✓ 2000-3 Arapaho Road  
Streetscape - 1999

DATE	5-24-99	JOB NO.
ATTENTION		
RE:	Arapaho Rd	
	Quorum Rd Tree Wells

COPIES	DATE	NO.	DESCRIPTION
3			Replacement Detail (A), Sheet LC-3 and Typ. Section through Tree Well

TYPICAL QUORUM SIDEWALK PLAN DETAIL (A)  
 1/2" = 1'-0"

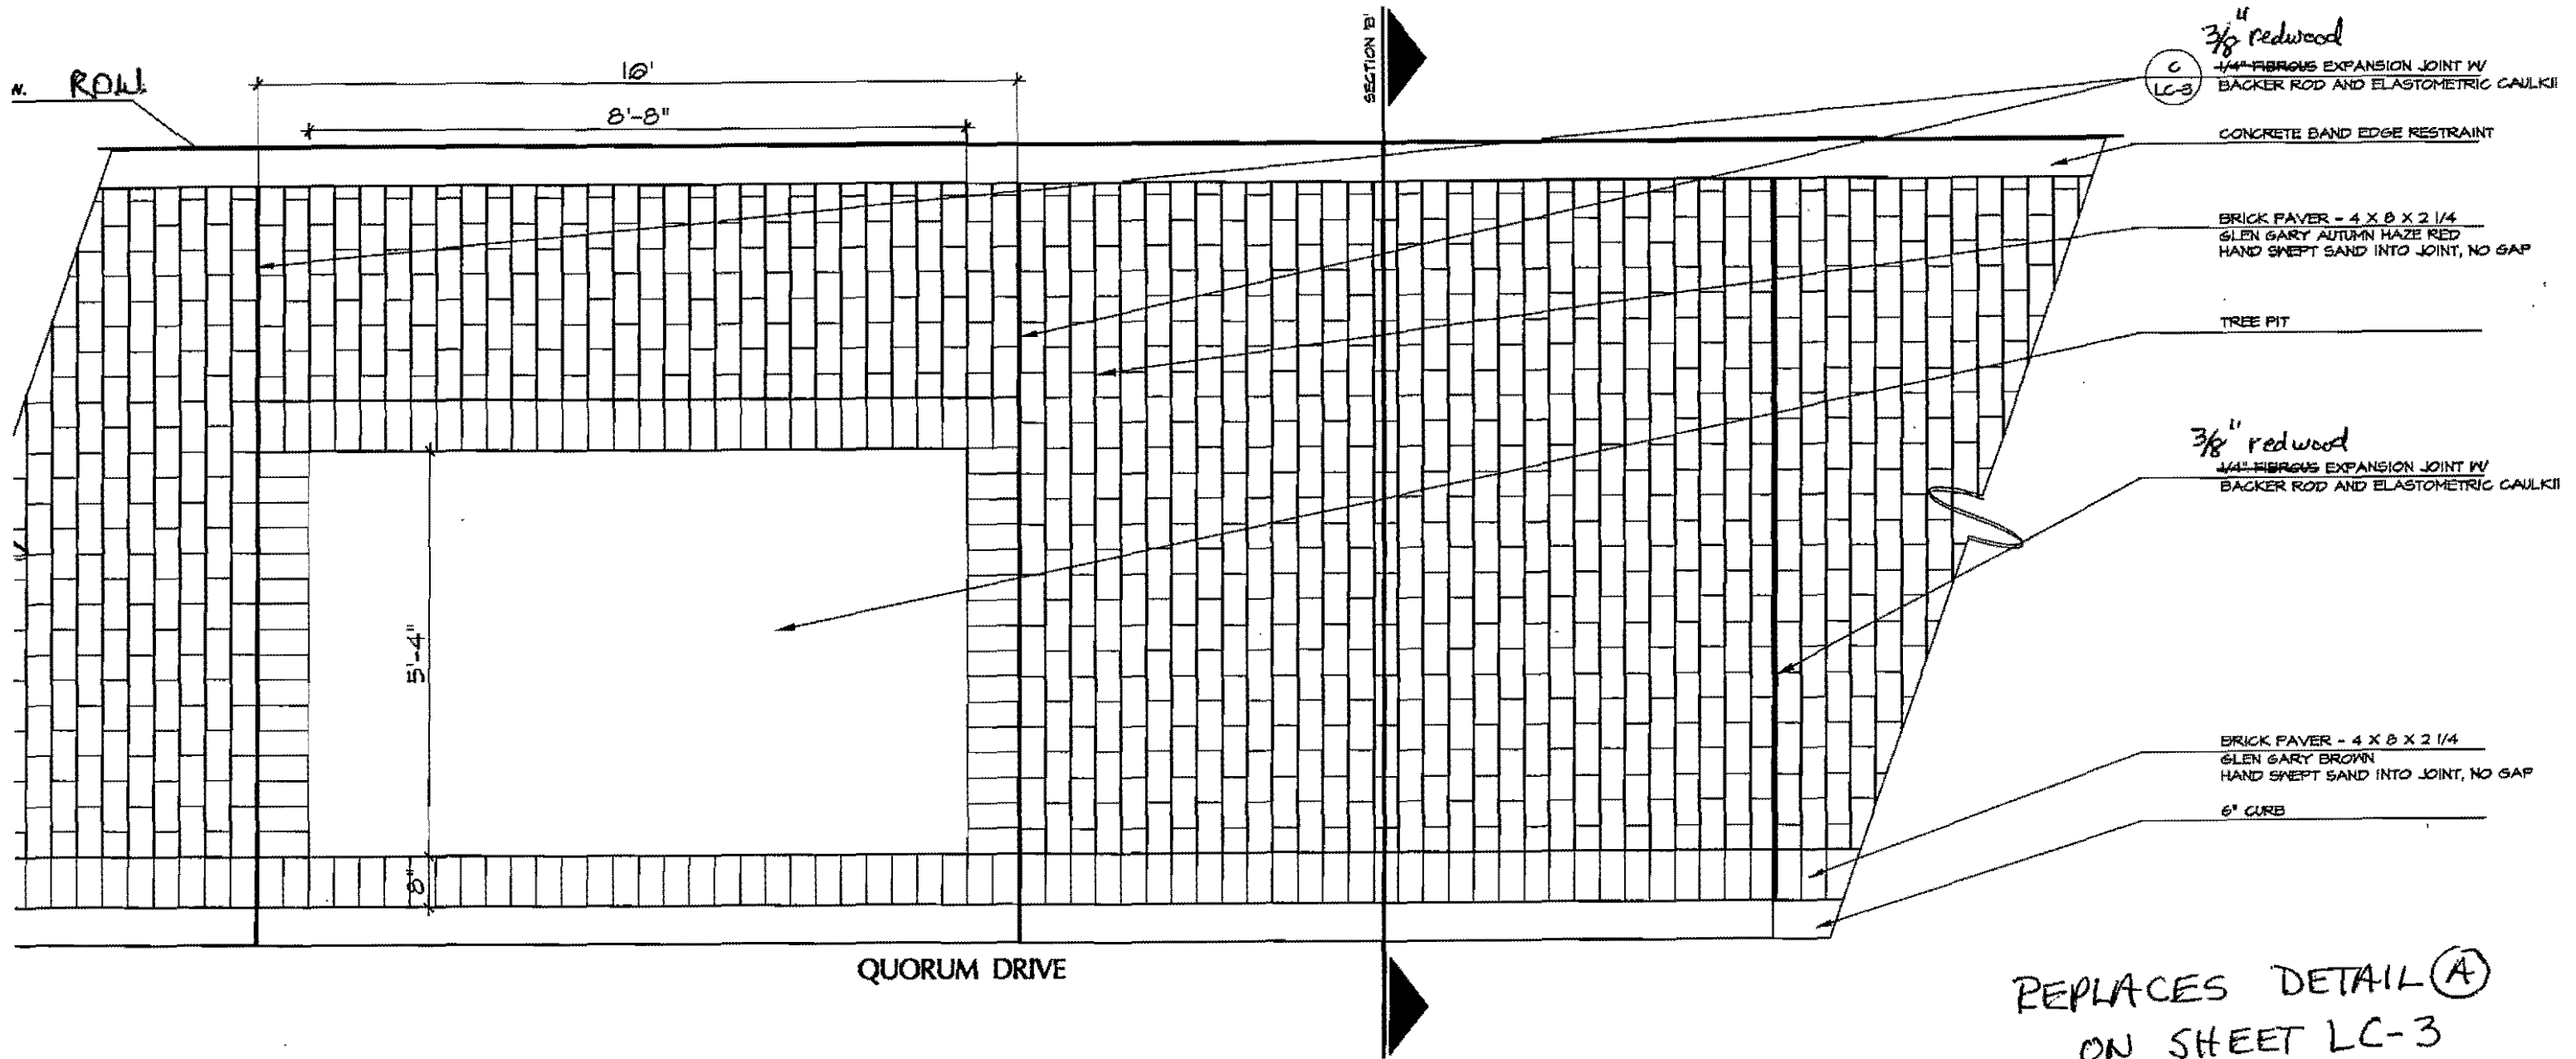
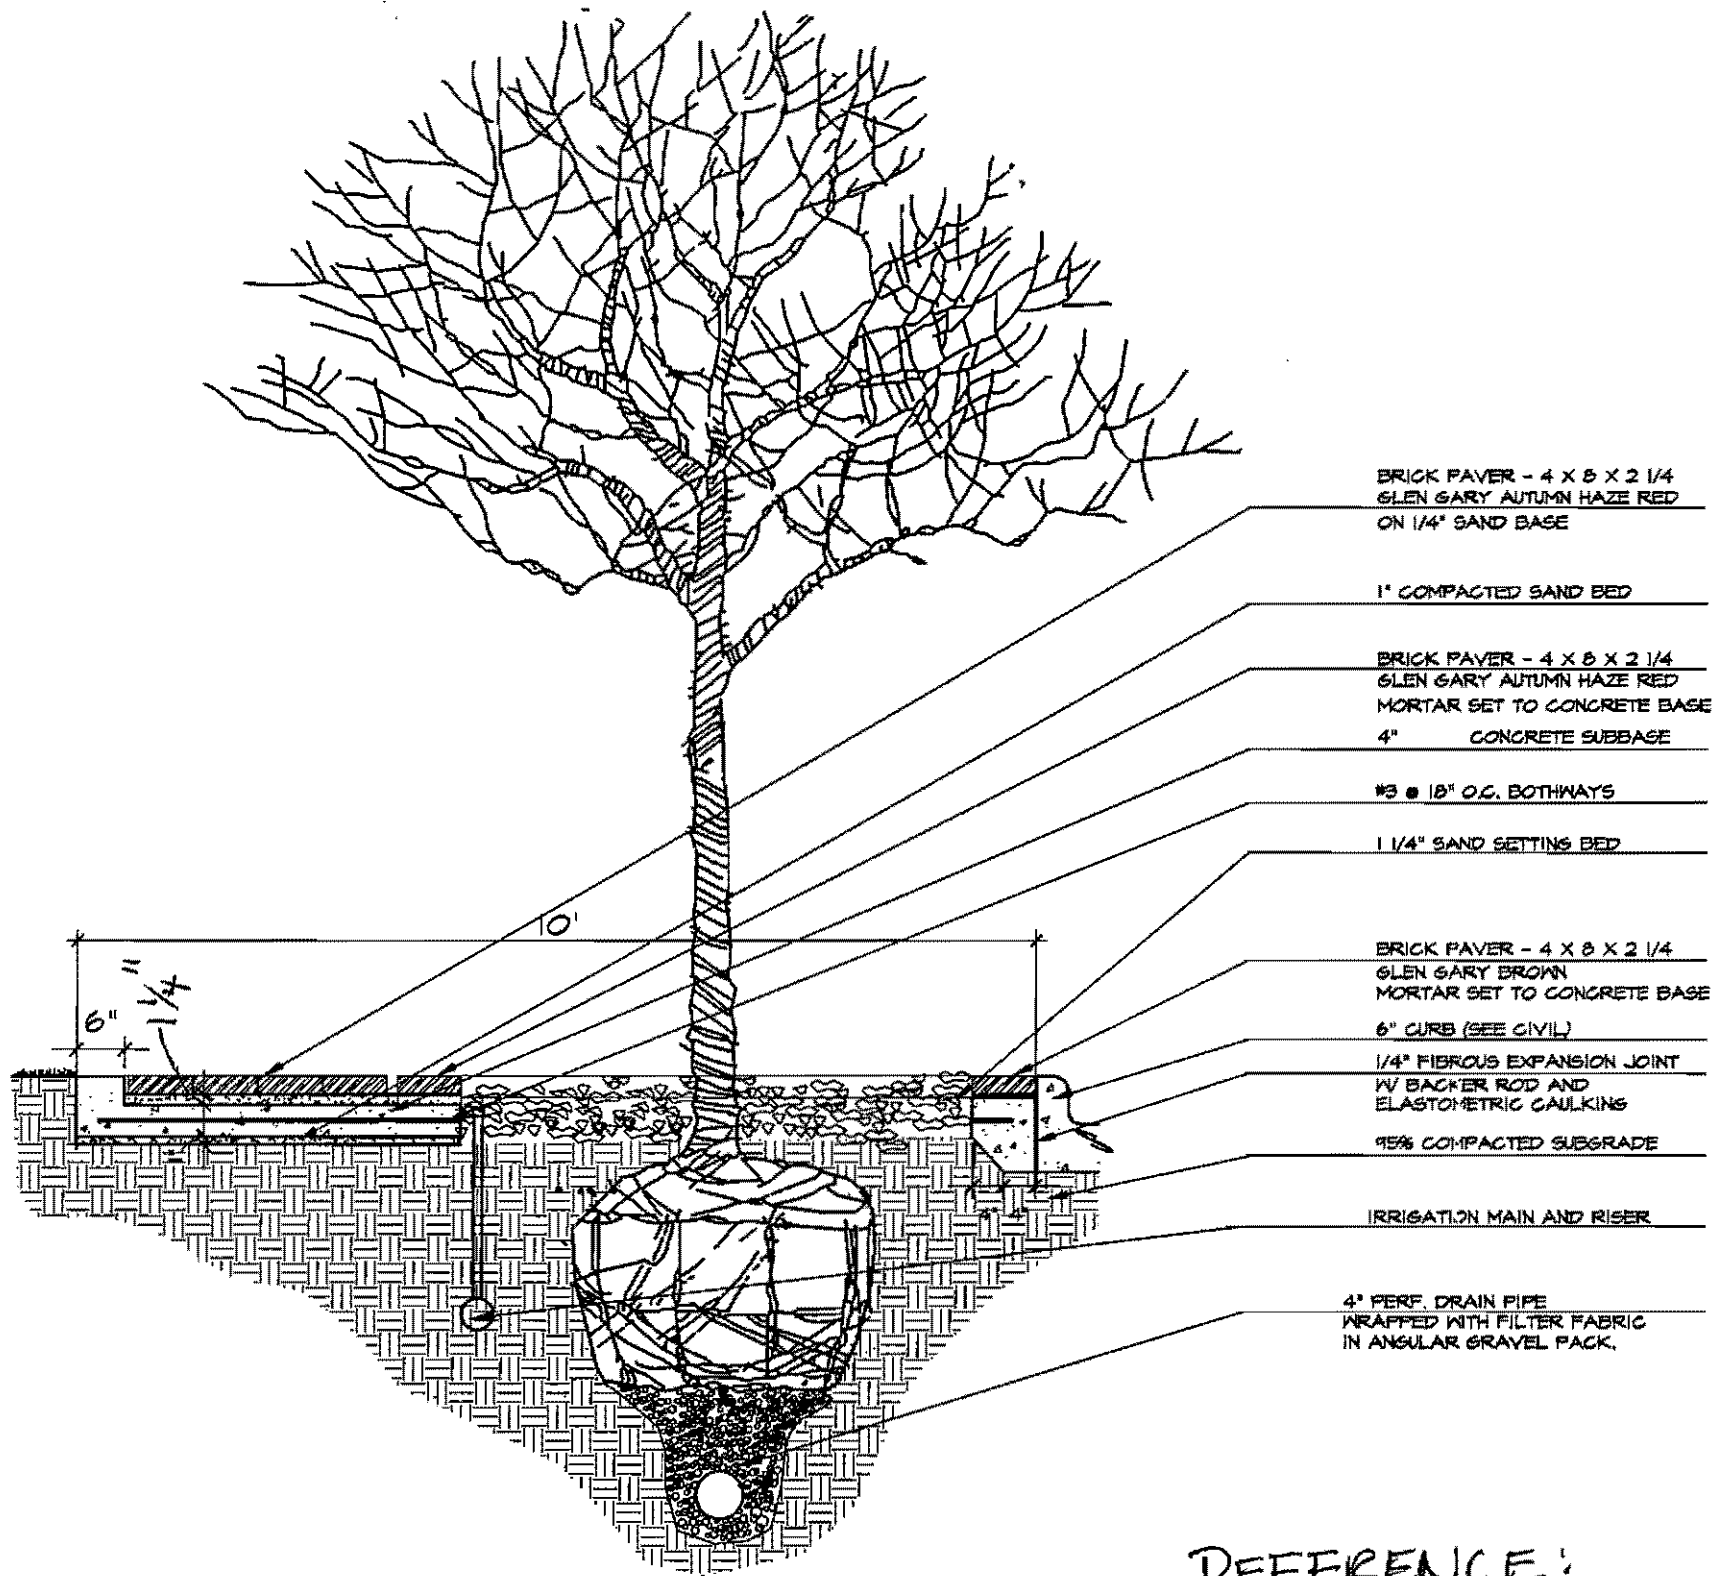
Note the soldier course of brick has been eliminated, the tree well edge brick are mortared in place and the tree well width has been increased to 5'-4"

REPLACES DETAIL (A)  
 ON SHEET LC-3  
 5-24-99  
 Johnson

Quorum Drive Tree Drain  
Location

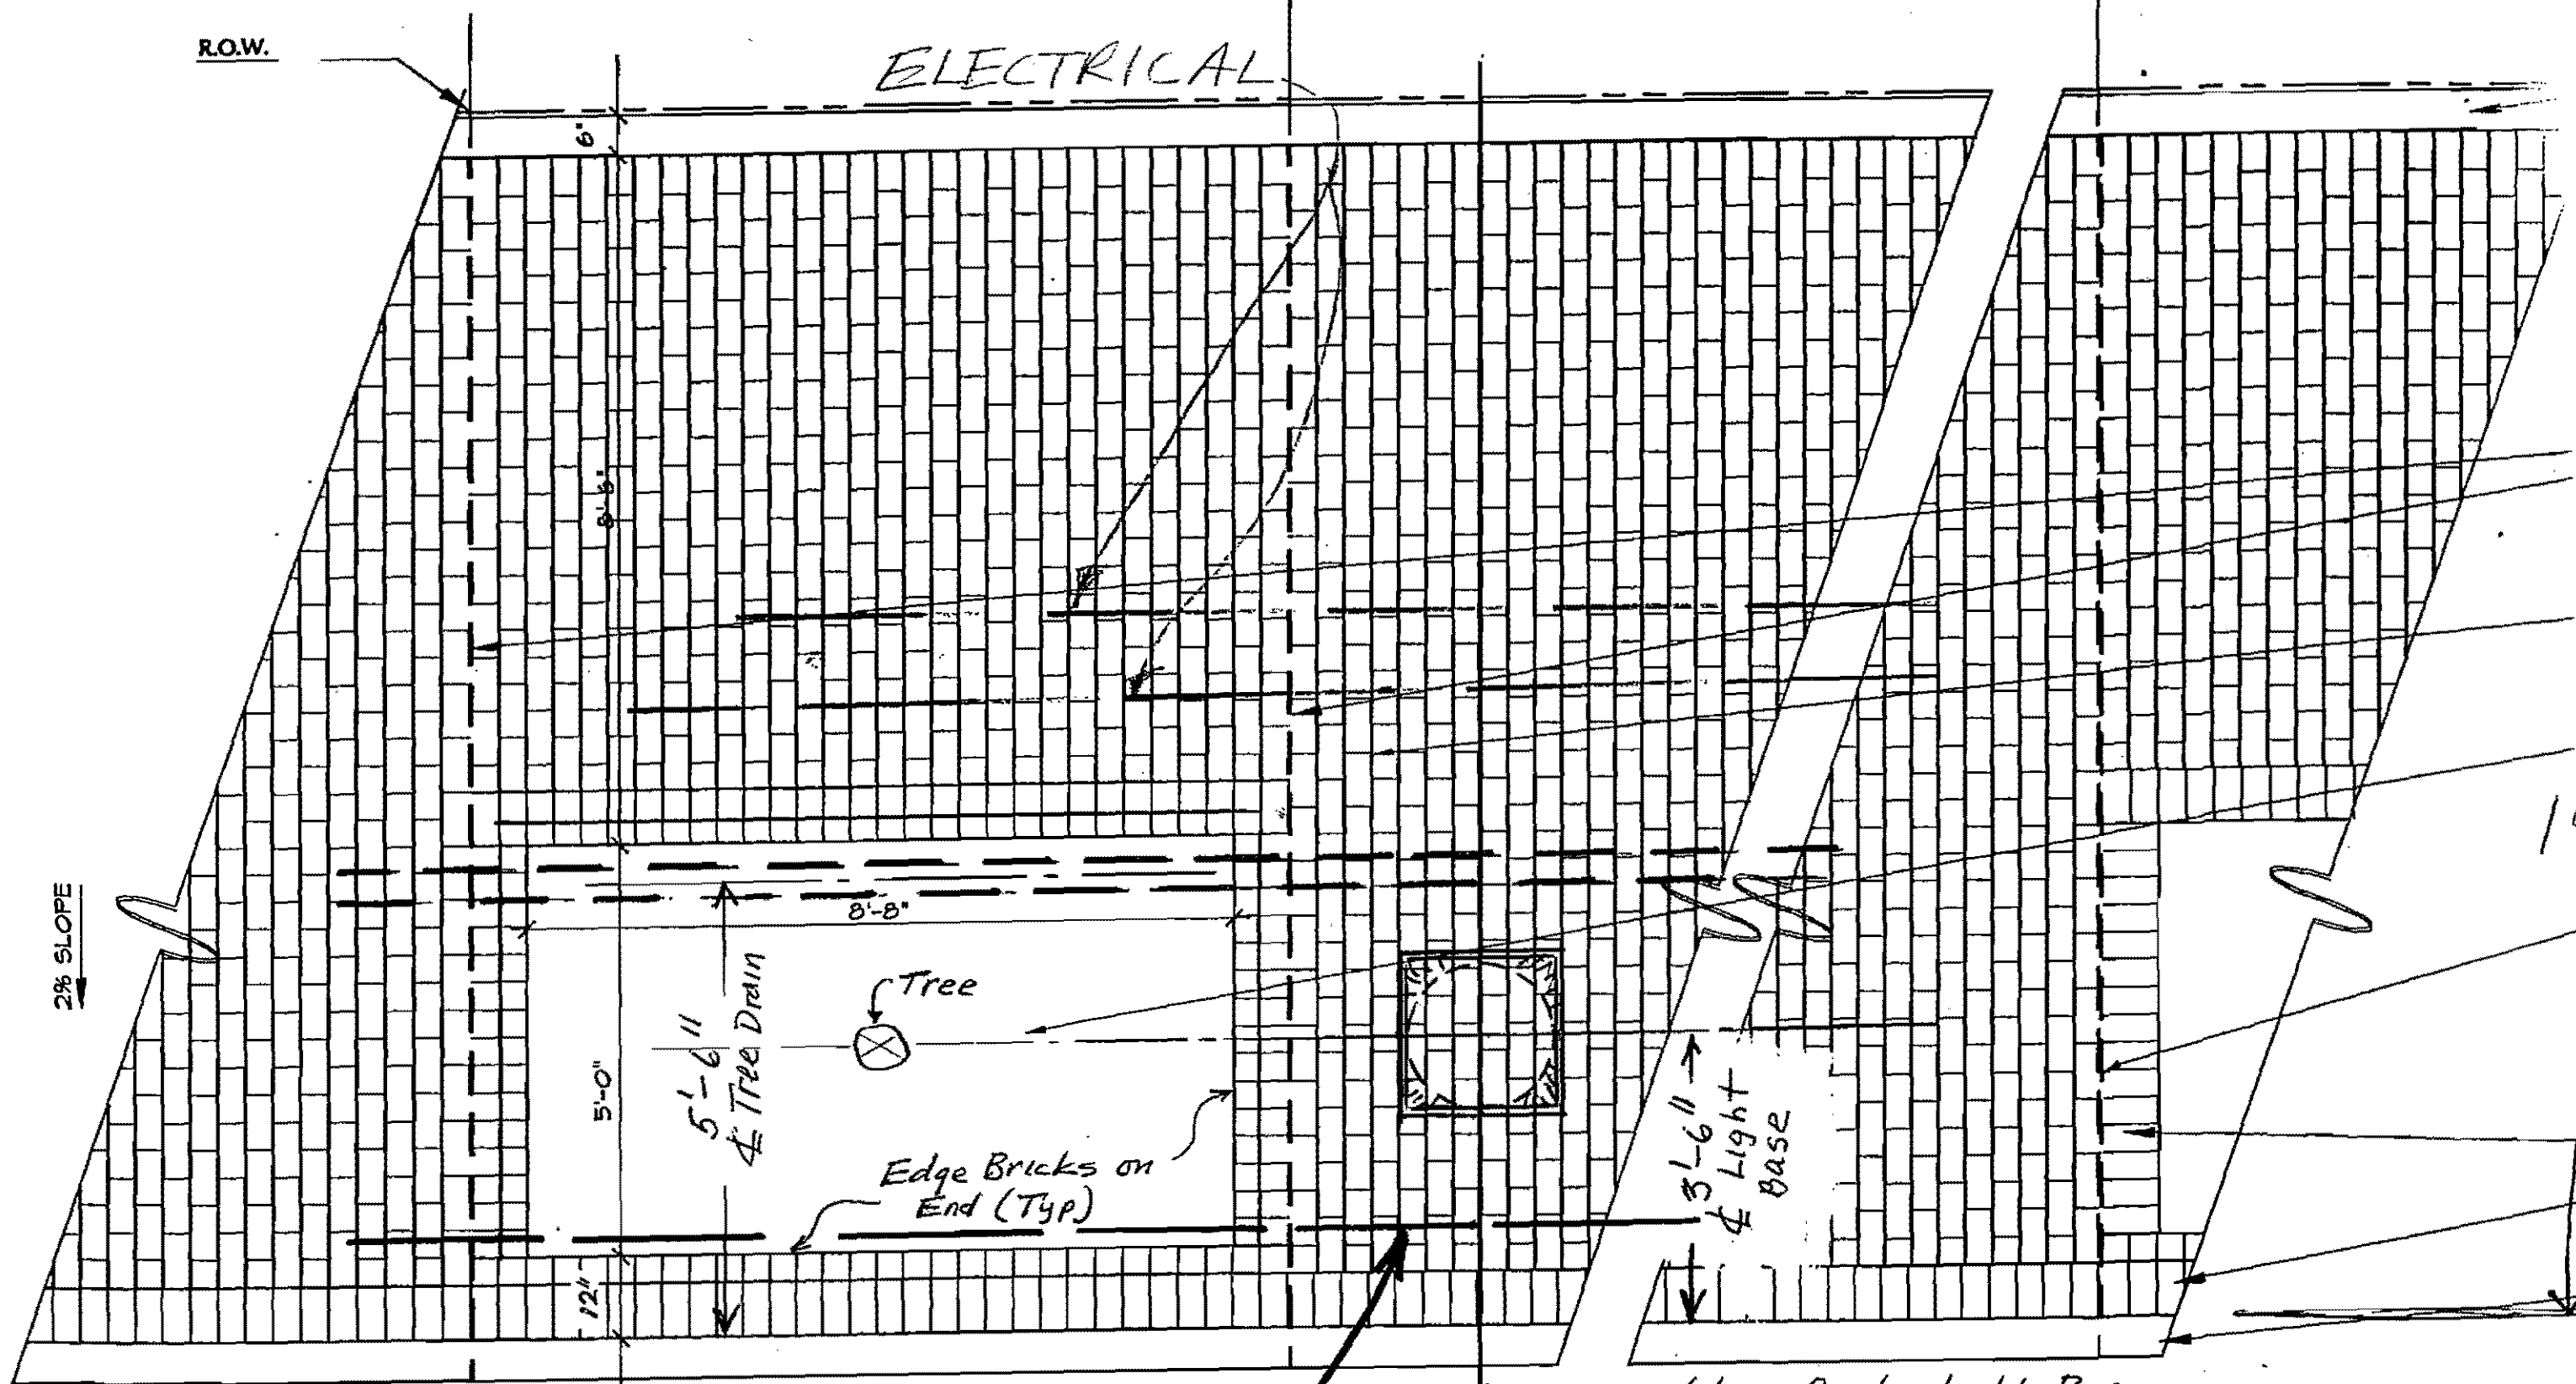
**REMARKS** This is to direct you to install tree well drains on Quorum Drive (both sides) north of Arapaho Rd. Tree well drains shall be connected to the flow line of the inlets and carried at curb grade for drainage into the inlets. Drains shall be 5'-6" back of back of curb as shown. Existing unit prices shall be used to pay for the work and quantities shall be increased accordingly. Pedestrian light-base locations shall be revised as shown (Arapaho Rd).
